DESIGN CALCULATIONS

Alternative analysis of the MTC
well stresses during lift

SIERRA NUCLEAR CORPORATION

WEPCo

FIGURE 1 (COMMENT 2#3) SCALE DWG OF MTC/VCC

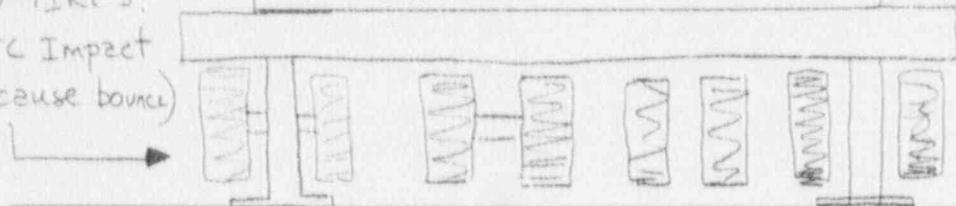
A lift of approximately 3 ft (see attached Figure) would be required before the MTC would be high enough to tip and get its cg over the edge such that it would fall off. This is clearly much higher than the cask could get with a failing lid. At crane speeds of 2 to 6 ft/min, 30 seconds or more would be required for the lid to hold and then fail. However, the operator is only going to "bump" the MSB weight off of the doors and, hence, the crane should only be on for less than a second. Even if the operator erred severely, the MTC would only be lifted an inch or less. Hence, even if the operator erred severely and the lid and/or bolts failed (two concurrent unlikely events), the MTC would only move a few inches or less, and (as considered in both NUREG 0612 and past Part 72 licensing conditions) a movement of 12 to 18 inches is not considered a drop. Therefore, even if everything that could go wrong went wrong the event would not be considered a heavy load drop and the MTC would not topple. The MTC is prevented from toppling by the potential height of the drop, the large area of the concrete cask and the MSB connected to the crane and still wholly or partially inside the MTC. See the attached figure for a sketch of the situation.

HANGING MSB
WOULD PREVENT
ANY TIP-OVER
OF MTC EVEN
IT WERE RAISED
TO OVER 3 FT
(i.e. MTC cont
fall crooked
it has to slide
down MSB)

MTC cannot
rotate this far
due to MSB
inside.

NOTE WIDTH OF
VCC COMPARED
TO MTC. VCC
IS VERY STABLE
100 TON WORK
PLATFORM.

NOTE TRAILER
IS ON JACKS
DURING TRANSFER
NOT ON TIRES.
(i.e. MTC Impact
won't cause bounce)

FIGURE 2.1-1 (PWR)
 NUMBER OF FUEL ASSEMBLIES THAT COULD BE DAMAGED TO REACH 1/4 OF 10 CFR PART 100 LIMITS VS TIME AFTER REACTOR SHUTDOWN

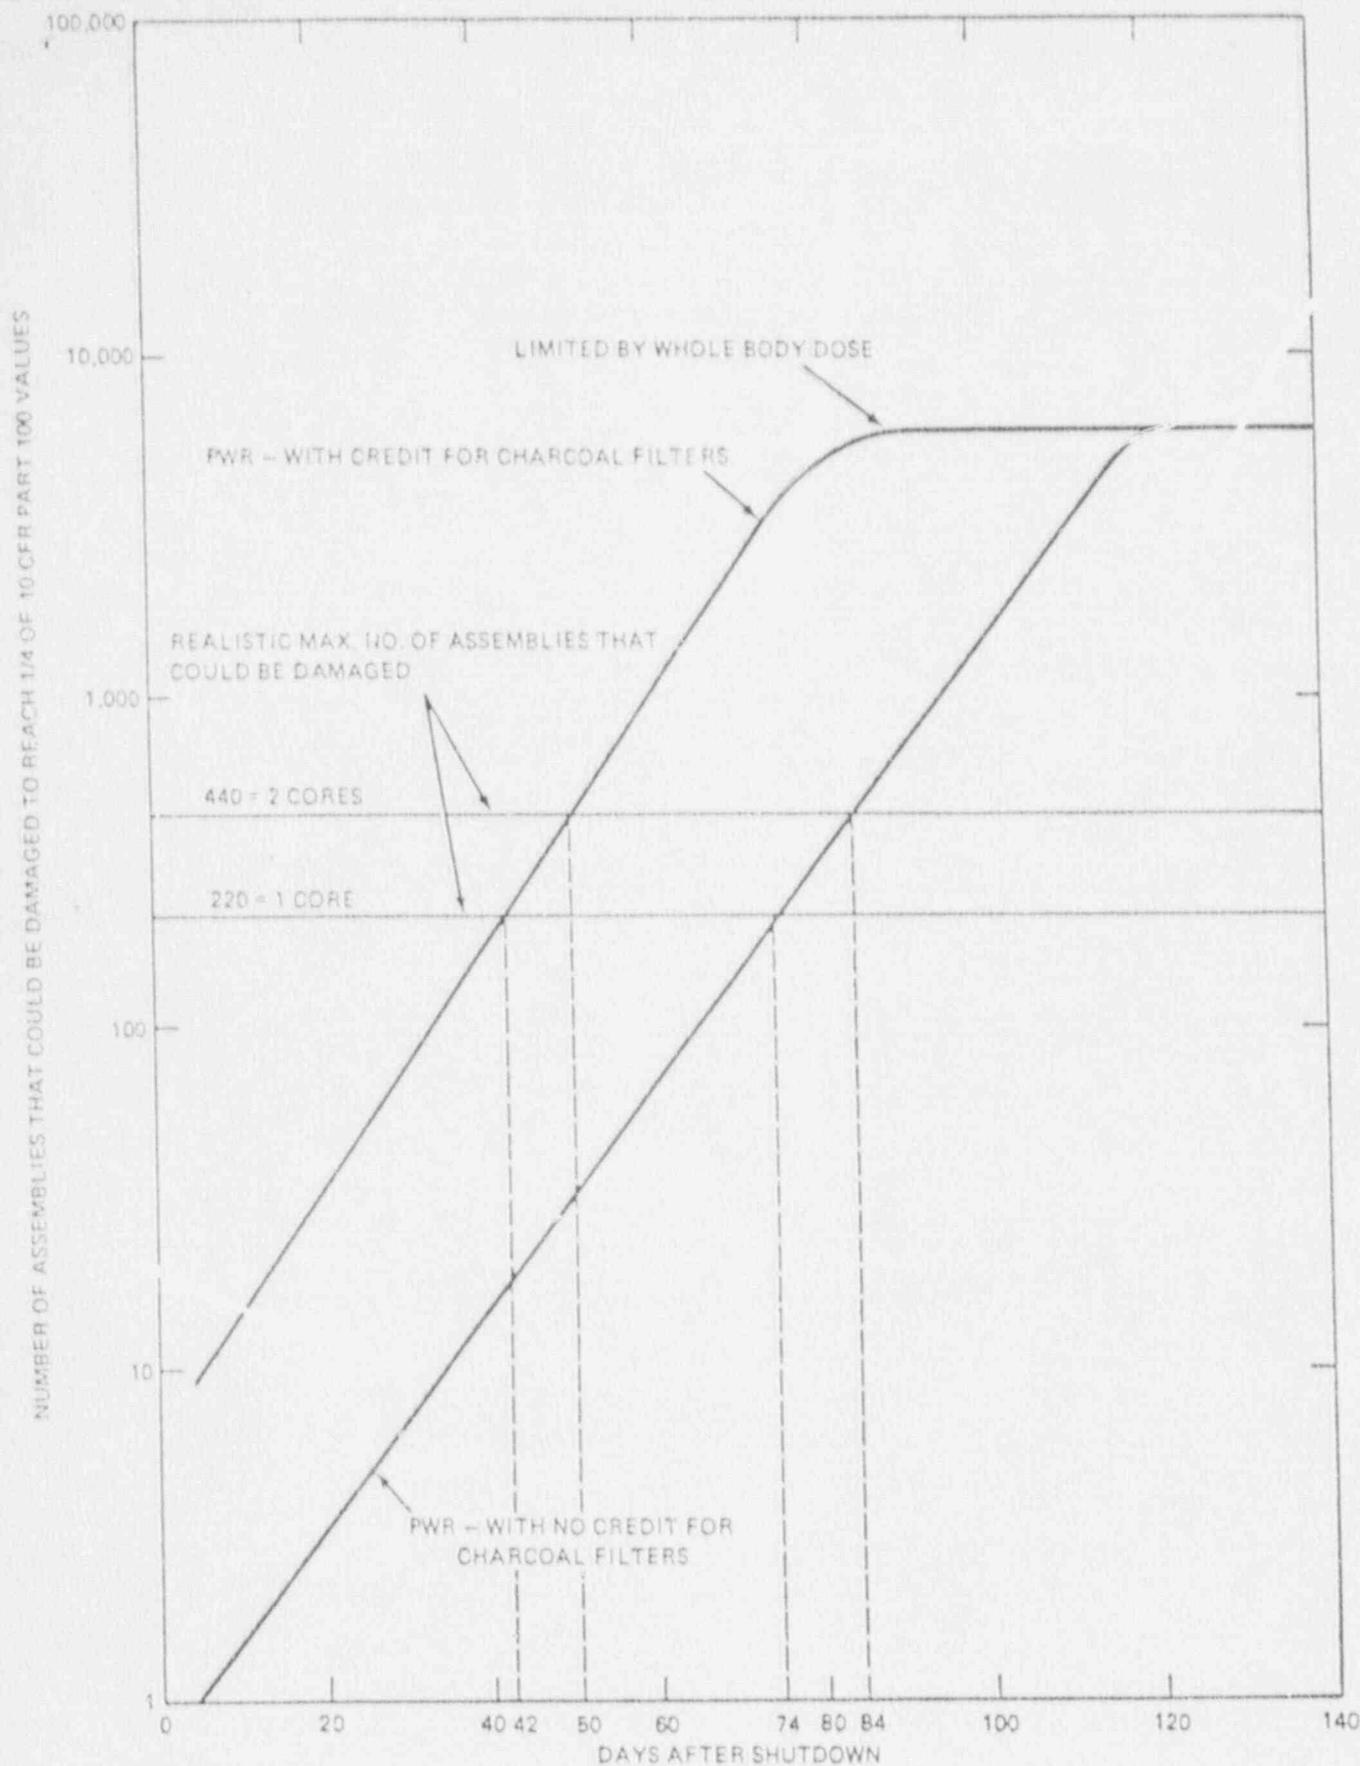
1. Doses less than 1/4 of 10 CFR 100 limits per attached figure.
2. $k_{\text{eff}} \leq 0.95$ because no moderator present.
3. No possibility of damage to reactor vessel or spent fuel pool.
4. No damage to redundant or dual safe shutdown equipment - damage will be to empty concrete cask and trailer.

FIG. 3. Design chart for Category I fracture critical components.

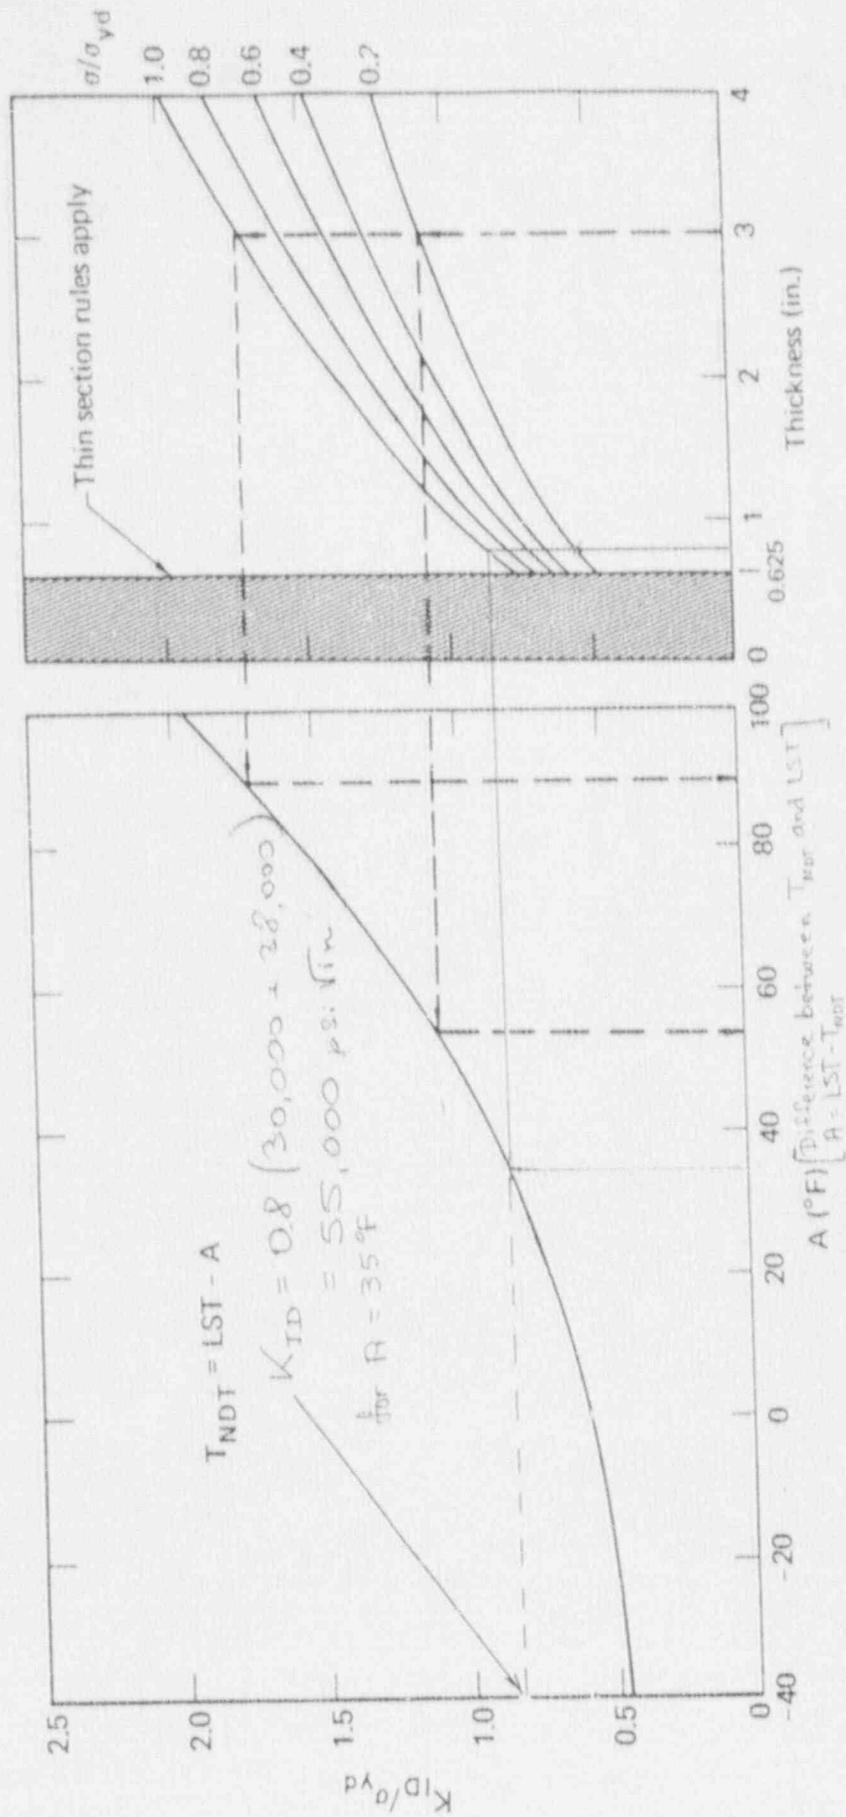
2.5°F is the Lowest Service Temperature (LST) as determined by PSN. PSN also calculated that in order to avoid brittle fracture, the materials Nil Ductility Transition (NDT) Temperature has to be 35°F below the LST, i.e., -32.5°. It is our understanding that the NRC staff agrees with this. Please see attached Figure 3 of Section 5.1.1 (NUREG/CR-1815).

NOTE: From above for our $LST = 2.5^\circ\text{F}$ we get $NDT = -32.5^\circ\text{F}$

FIG. 2. Design-reference curve relating K_{ID} and the temperature relative to NDT (from Ref. 3).

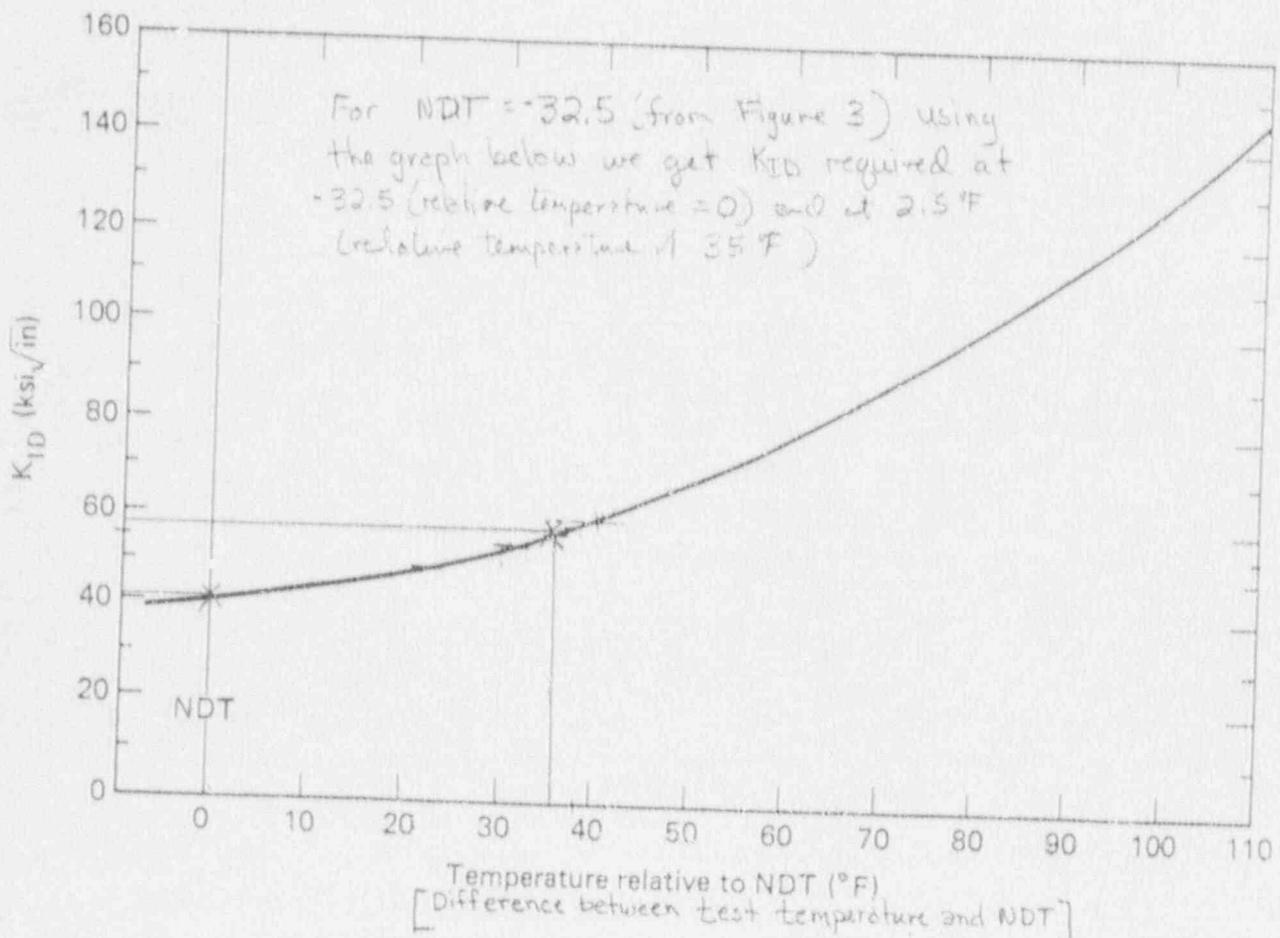
However, Section 5.1.1 does not relate the NDT temperature of the material to the Charpy V-notch data. This is done by Figure 2 and Section 4.2 of NUREG/CR-1815 (attached). Note that this is stated in Section 5.1.1 (bottom of page 15).

and find from Figure 2 that -32.5°F is the NDT temperature of the material. On the other hand, if one test the material at 2.5°F and the result is 25 lb•ft, the K_{ID} is

and (from Figure 2) the test temperature of 2.5°F is 35° above the NDT temperature of material (which is then -32.5°F).

Therefore, in both cases the results are the same: the NDT is -32.5°F. PSN specified 12.6 lb•ft at -30°; however, we would achieve the same purpose if we required 25 lb•ft at 2.5°. At the same time, the NRC suggested requirement of 25 lb•ft at -30° would require NDT of -30° - 35° = -65° which is not necessary.

FIGURE 1
 COMPARISON OF NEUTRON DOSES
 FROM AHS CORNITE, MC-10 and USC

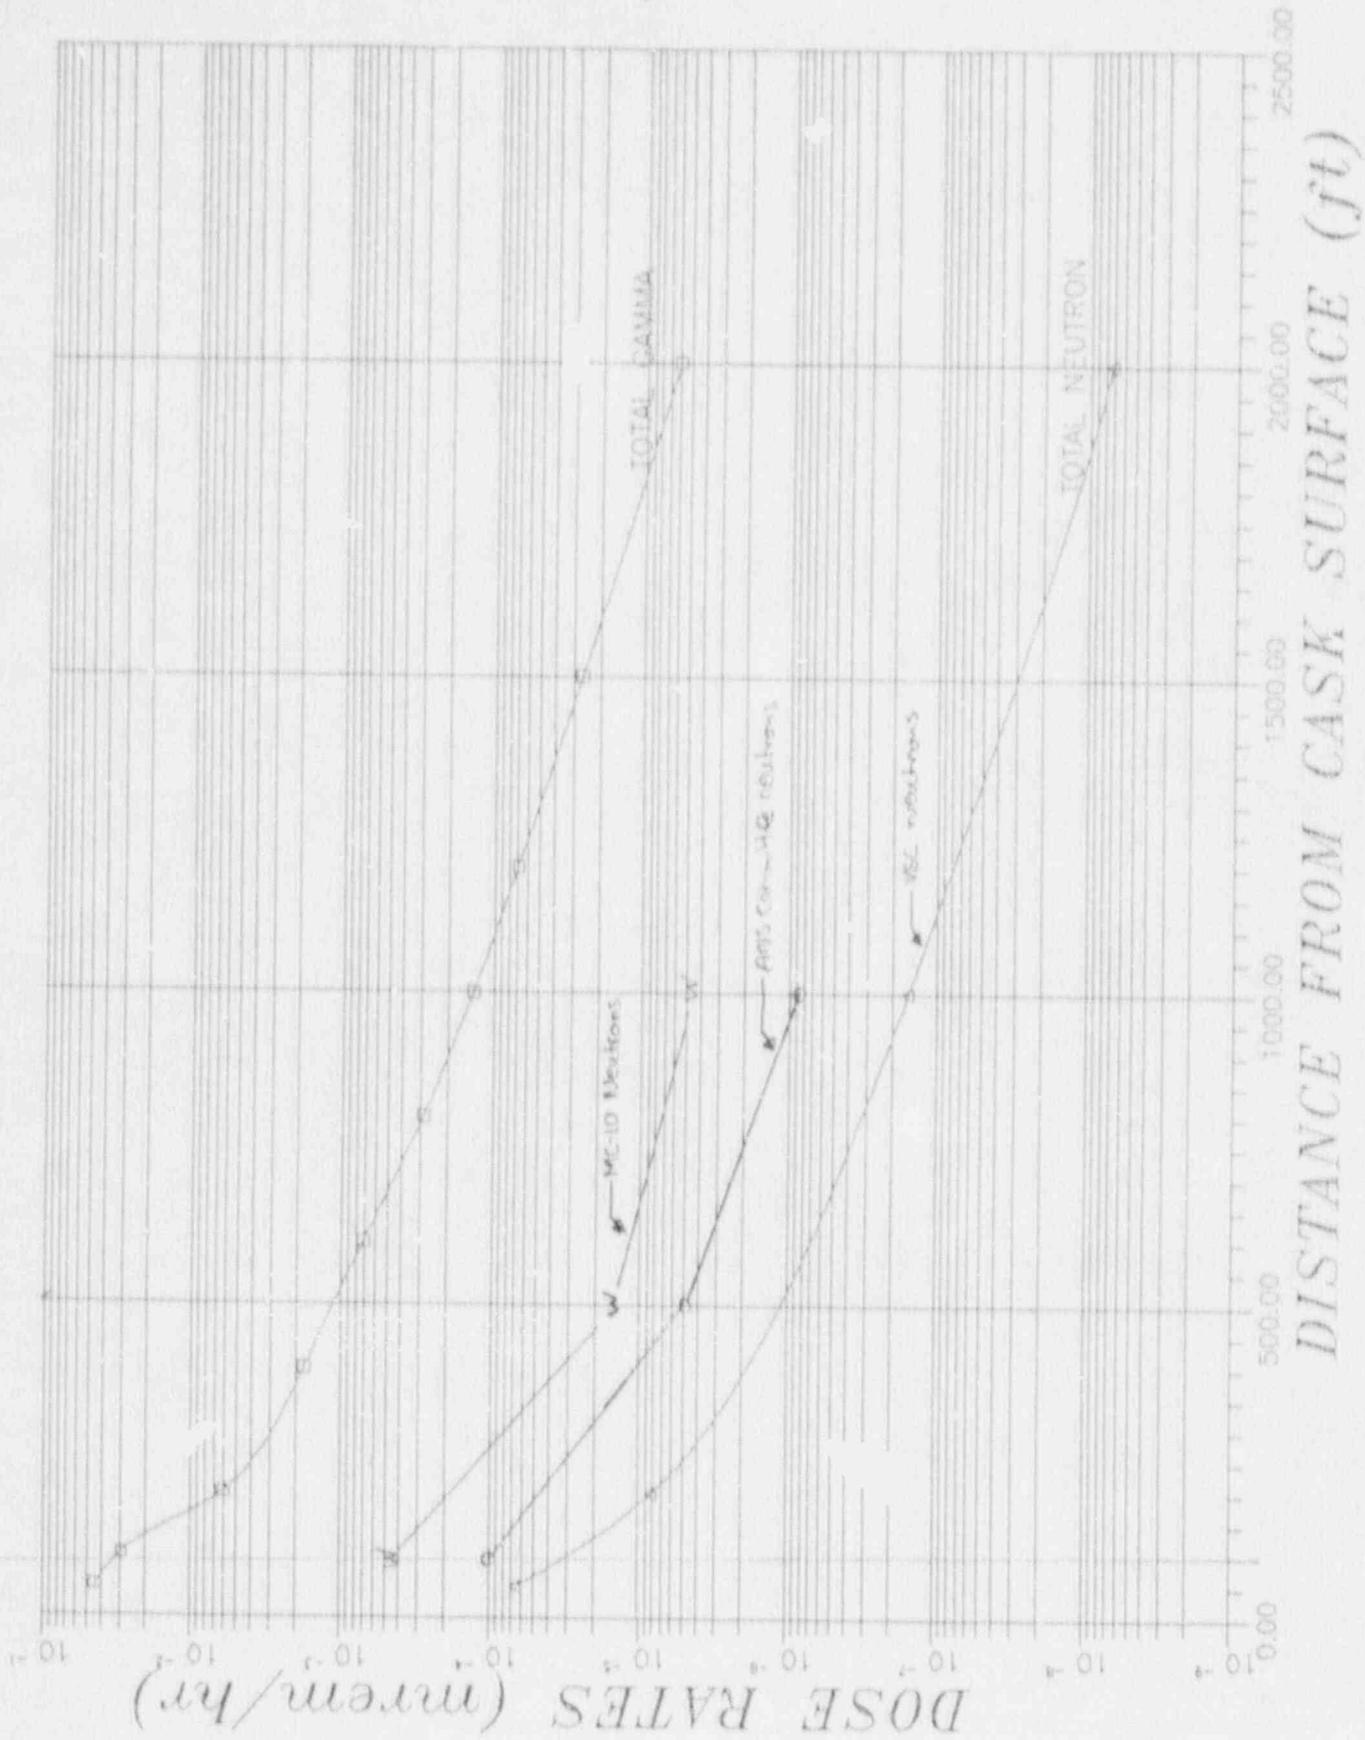
In response to the differences between the MORSE and SKYSHINE calculated neutron dose rates we would like to point out that variations of 36 to 77 times are typical for neutron skyshine. Results are very dependent on calculational technique, source strength (was the peak or average surface dose rate used), geometry, detector location, meteorological conditions, etc. Such variations have been documented by the ANS committee on neutron skyshine. However, further work was not done because no one in the industry (NRC, EPRI and utilities) has determined from operating data that any excessive doses are coming from neutron skyshine. One can only assume that if such is the case then the lower calculated neutron dose rates must be closer to actuality than the

As a summary, Figure 1 shows a comparison between PSN's calculation, the ANS committee calculation and another dry storage technology topical (MC-10). The table above provides a comparison of the surface dose rates. The curves shown in Figure 1 are corrected by the product of surface dose rate times the area to account for source differences. While the VSC doses are lower than the other calculations they are within one order of magnitude variation from the results found by the ANS committee.

Figure 2
Comparison of γ Doses Between MC-10
vs. a. & NUHOMIS

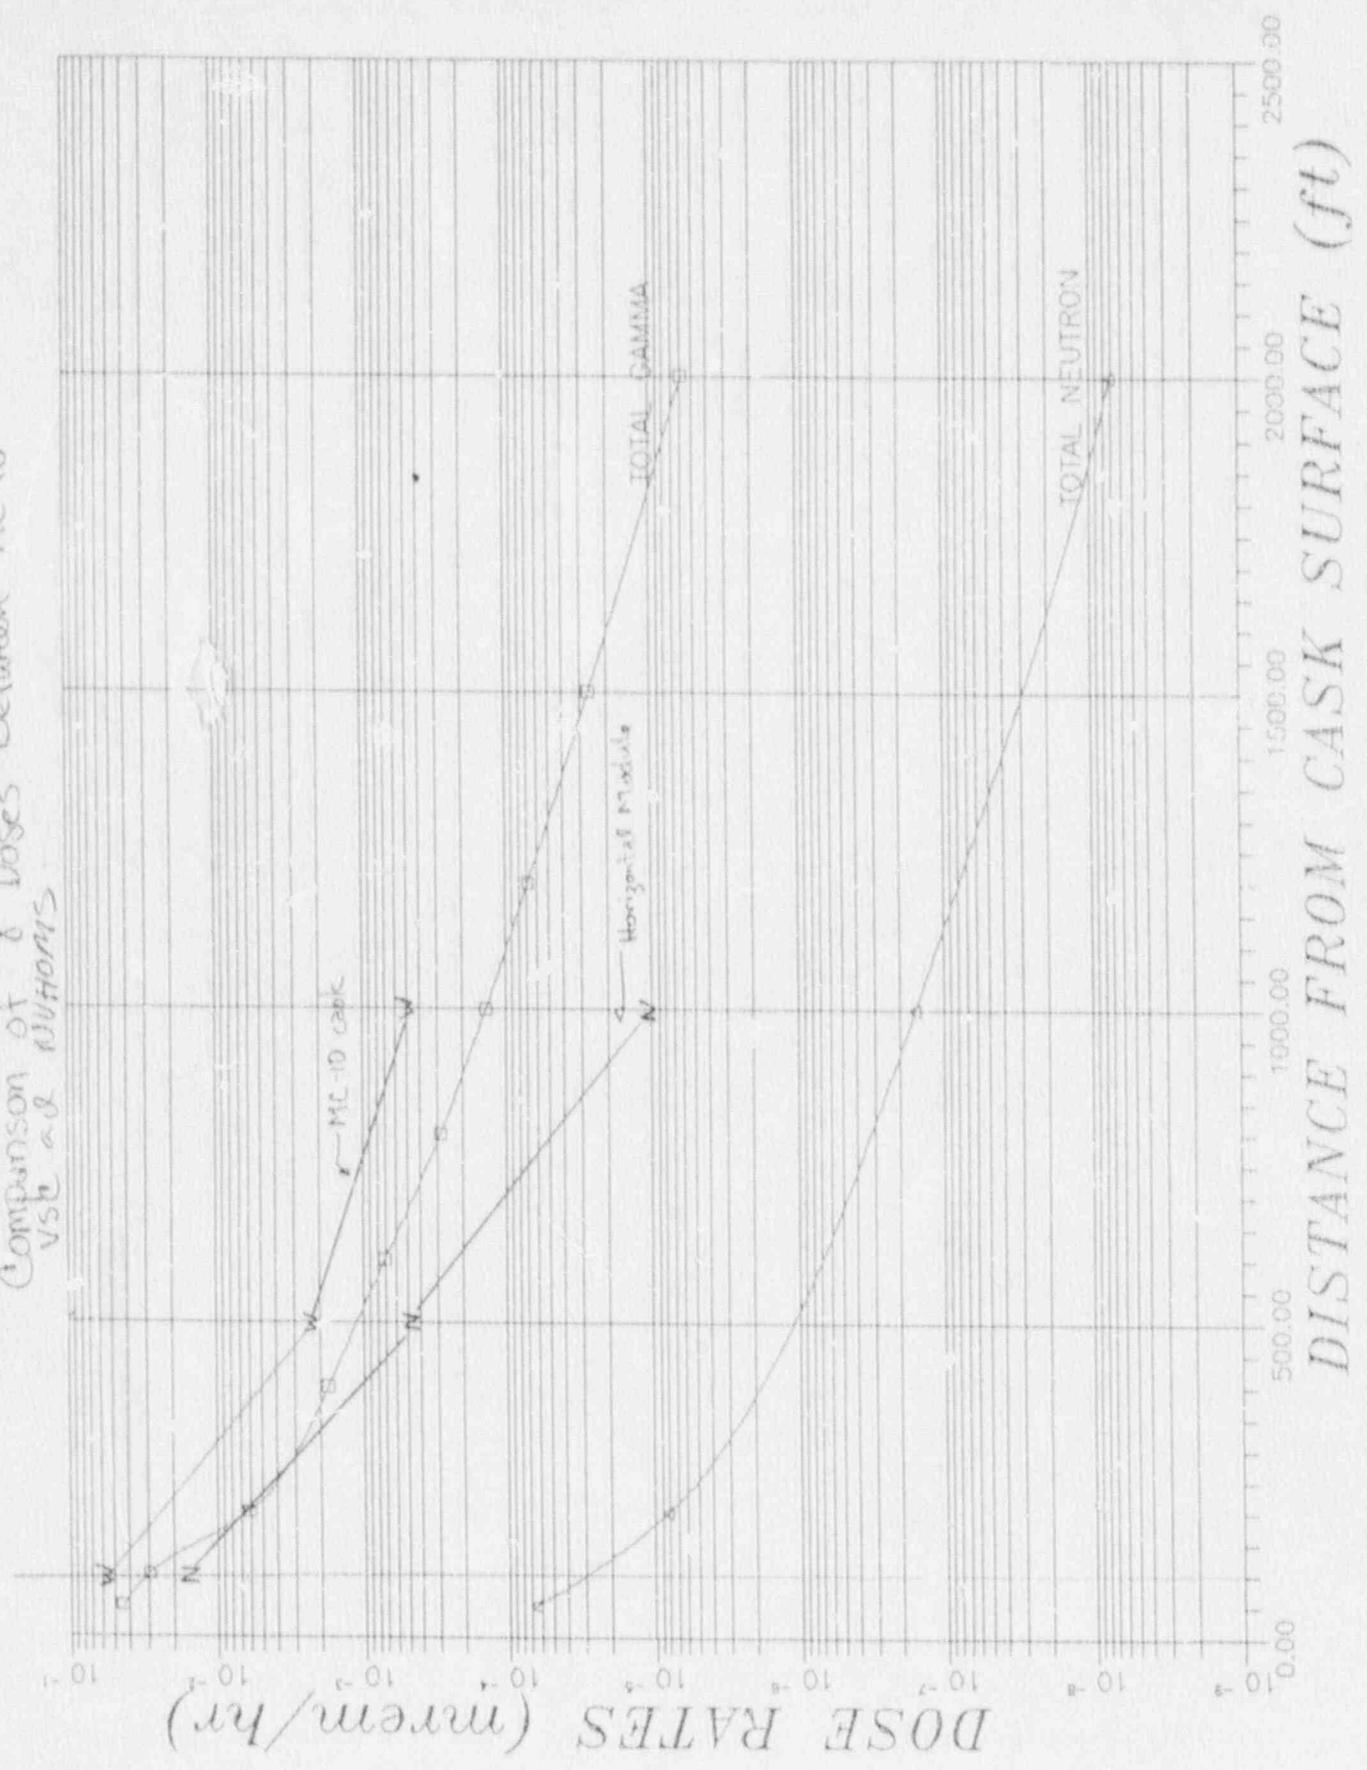
Also, in regard to the question of the gamma dose rate: Figure 2 is presented to show that our calculation compares excellently with other calculations.

In closing, we have validated our SKYSHINE analysis against other calculations for both neutron and gamma radiation as evidenced by the enclosed graphs. As our surface doses are lower than other, already licensed casks, we believe this to be sufficient.
